From: s22
To: s22
Cc: s22 ; 's22' ; Blewett Richard; s22 ; "s22"
Subject: RE: CSIRO-Geoscience Australia Tranche 2 Report for the Carmichael Coal Project [DLM=For-Official-Use-Only] [SEC=UNCLASSIFIED]
Date: Friday, 22 February 2019 4:42:57 PM
Attachments: [image001.png](#)
[image002.png](#)
[image003.png](#)
[image004.png](#)
[image005.png](#)

Dear s22
Attached is the joint CSIRO/GA submission for Tranche 2 of the DoEE advice request for Carmichael Coal Mine Project. Tranche 2 is a focused review of the draft groundwater management and monitoring plan and draft groundwater dependent ecosystem management plan provided by the proponent, looking at use of groundwater modelling and approaches to monitoring and management. This advice also includes Tranche 1 and pre-Tranche 2 reports. If the Department has specific questions regarding this submission, please contact s22 s22 @ga.gov.au) for further information.

Title : CSIRO-Geoscience Australia Tranche 2 Report

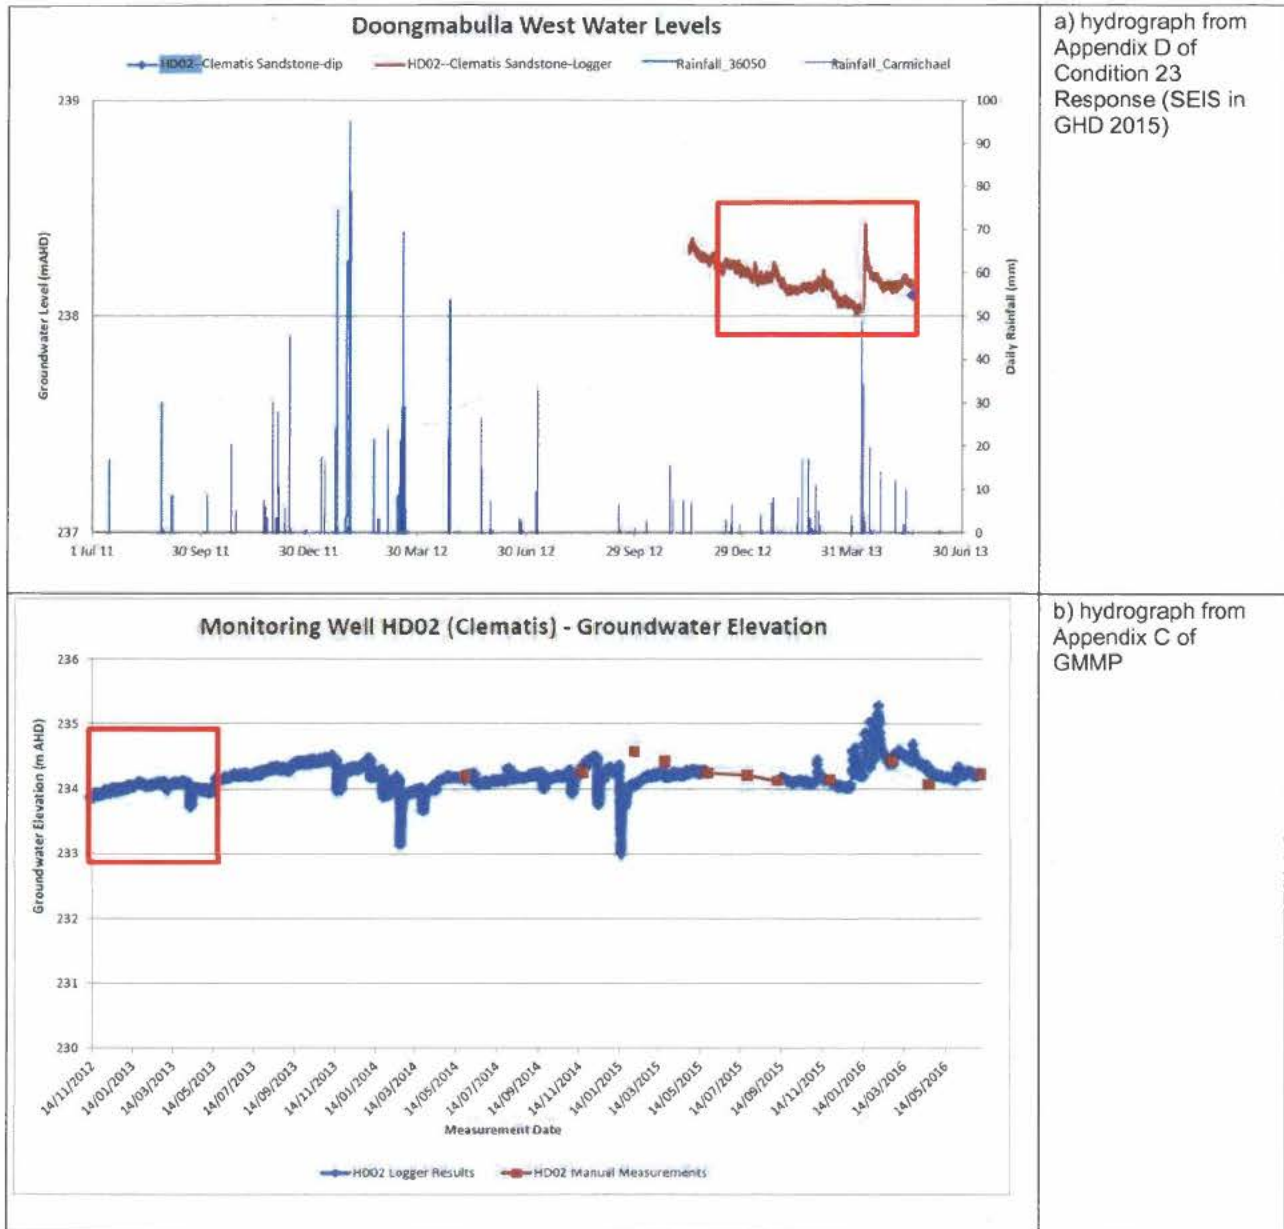
Figure 3: Response in Bore C027P2 - a) The SEIS (Appendix D in GHD 2015) and b) Appendix C of the GMMP. The red outline in both graphs denotes approximately the same time period. Vertical scale for both graphs is in mAHD
 a) the SEIS hydrograph of C027P2 Dunda Beds (purple line) shows correlation to rainfall gauge 36050
 b) the GMMP hydrograph of C027P2 Dunda Beds appears to be the vertical inverse of the same data for the same period as provided in the SEIS (Figure 3a).
